**BLOOMSBURY
CONSERVATION AREAS**
Advisory Committee | Est. 1968

2021/6078/P

Formal objection to application 2021/6078/P, at 11-12 Grenville Street.

Front Elevation

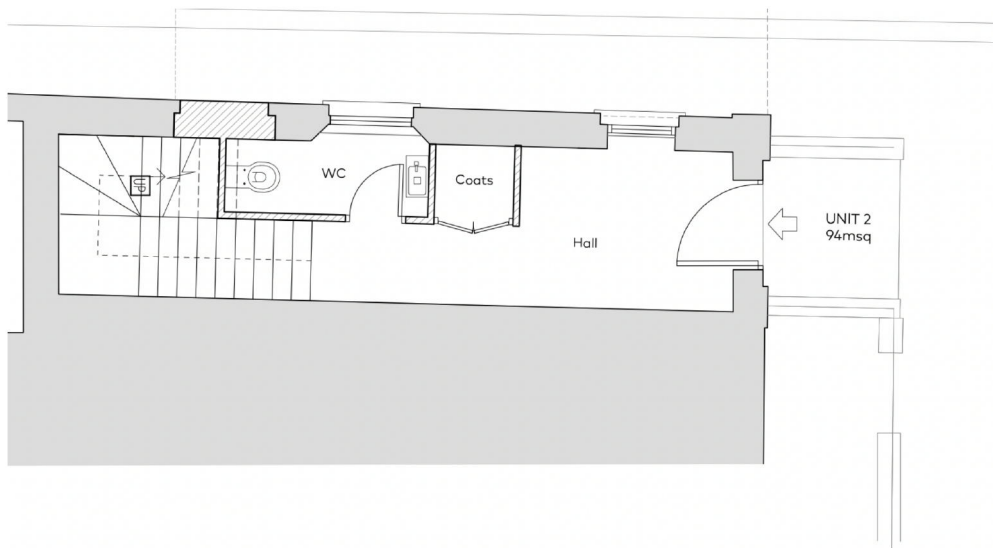
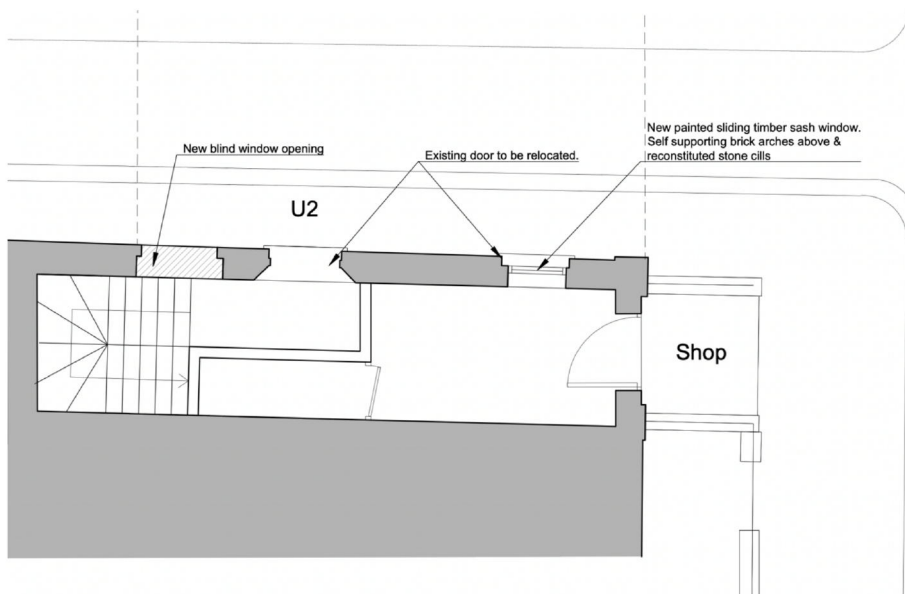
The application requests that an entrance hallway to a residential unit of 94m² is converted to a 'shop', whose only street frontage is a door. The door to the residential unit would then be moved to 'Colonnade' rather than Grenville Street. If an application were submitted for this alone it would be considered absurd for a number of reasons, but particularly because proposing such a space as a shop is contrary to basic town-planning principles of appropriate land-use. The historic significance of the NDHA and conservation area would also be negatively impacted by the conversion of an entrance to a Georgian townhouse into what would essentially be a shopfront.

This space is clearly designed as an entrance/hallway to the terrace above with a door onto the street and typical railings and steps as is usual of a Georgian house and indeed any kind of house. In terms of land-use a shop should be located inside a purpose-built premises with a shopfront rather than a

solid door. In terms of design there is simply not enough space for any kind of shop to function without it inevitably spilling onto the pavement and causing associated clutter and public circulation problems. As such we consider this contrary to Camden Local Plan Policy D3.

There also appear to be alterations proposed to the entrances to the residential units which would replace a traditionally detailed door with a solid panel door. We also object to this on this basis that it is inappropriate in design and heritage terms.
